### **ADDENDUM 3**

DATE: March 13, 2026  
TO: Prospective Bidders  
FROM: Steven Traynum, CSE Project Director

RE: **Isle of Palms Beach Nourishment Project**

**Figure 1:** Previously dredged area inside permitted borrow area. Permitted area shown in the black outline.

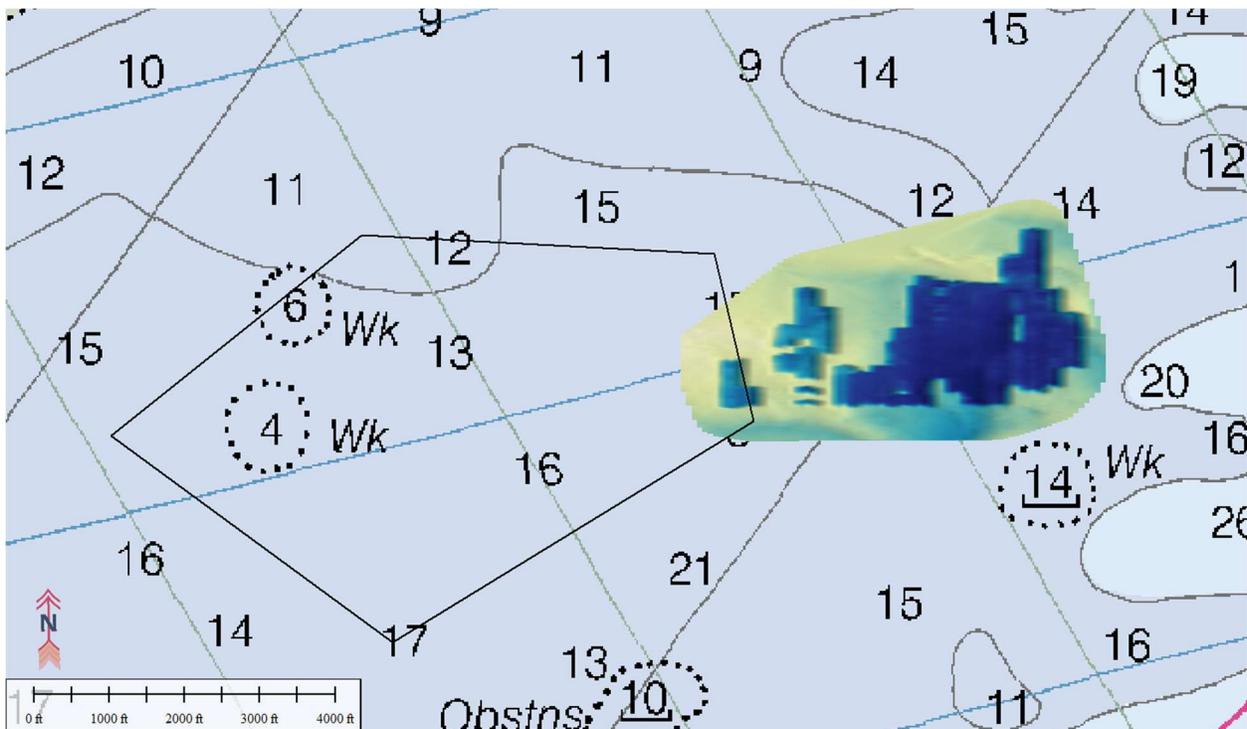
**Question 4** - Has this borrow area been used previously?

**Answer 4** – There is a small portion of the borrow area that was used during the 2018 Isle of Palms Renourishment Project. The figure below shows the approximate location of the previous dig in the southeastern corner of the borrow area. CSE has also uploaded the XYZ of the Borrow Area AD in 2018. The data included in Addendum 2 titled “240314\_Offshore\_OLD\_Borrow\_Area\_XYZ.xyz” shows the most recent survey of this area in 2024.
